<b>Date</b>	10 February 2026
<b>To</b>	Jon Bright, Project Director – Waitaha Hydro Scheme Westpower Ltd
<b>From</b>	Ian Ferrier McCahon
<b>Project advice provided for</b>	<i>Waitaha Hydro Scheme</i>
<b>Qualifications</b>	BE (Hons), <b>Appendix A</b>
<b>Code of Conduct</b>	<b>Appendix B</b>
<b>Documents referred to</b>	<i>Waitaha Hydro Scheme Substantive Application: Appendix 42 Concept Scheme Design Drawings</i>
<b>Signature</b>

1. I have reviewed the peer review report of Mr Paul Morgan and Dr Jon Tunnicliffe provided to the Waitaha Hydro Fast-track Panel and dated 26 January 2026. I have responded within my area of expertise and based on my involvement in designing the intake concept as an engineer involved in earlier stages of the Waitaha Hydro Scheme (before my retirement). My qualifications and experienced are described in **Appendix A**. My responses below cover both peer reviews.

Figure 3: Cross section close to upstream side of rock platform and approximate line of proposed weir. Note RL 238.0 line represents proposed weir crest.

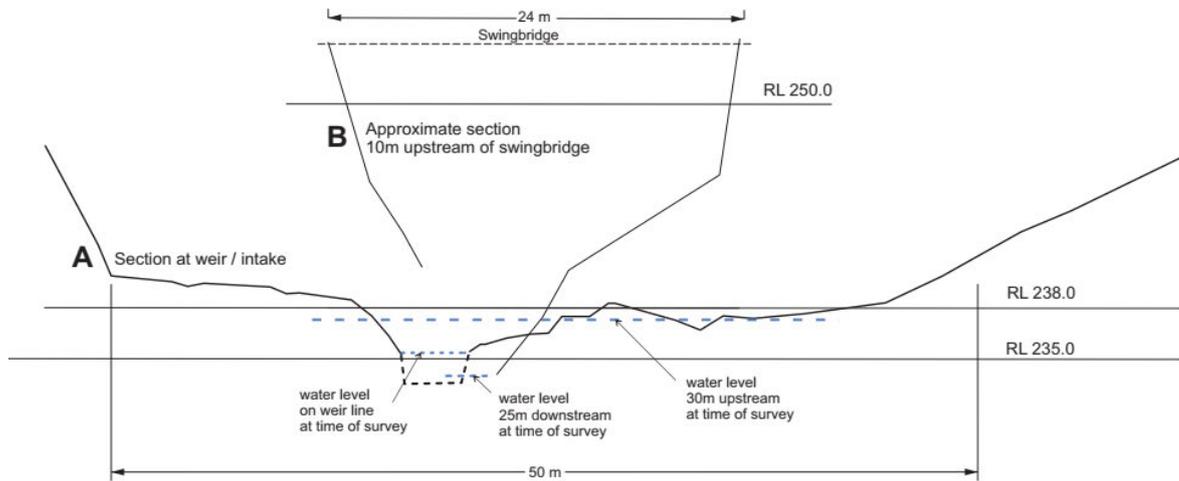
- (d) A 7m inferred weir height is in fact the height of the sluice gate structure, which will cut into the rock a similar amount. As seen on Figure 3, the weir itself will be about 3m above rock level across the existing river channel, but generally less than about 1m across the right side and 1m below the highest rock level profile on the left side.
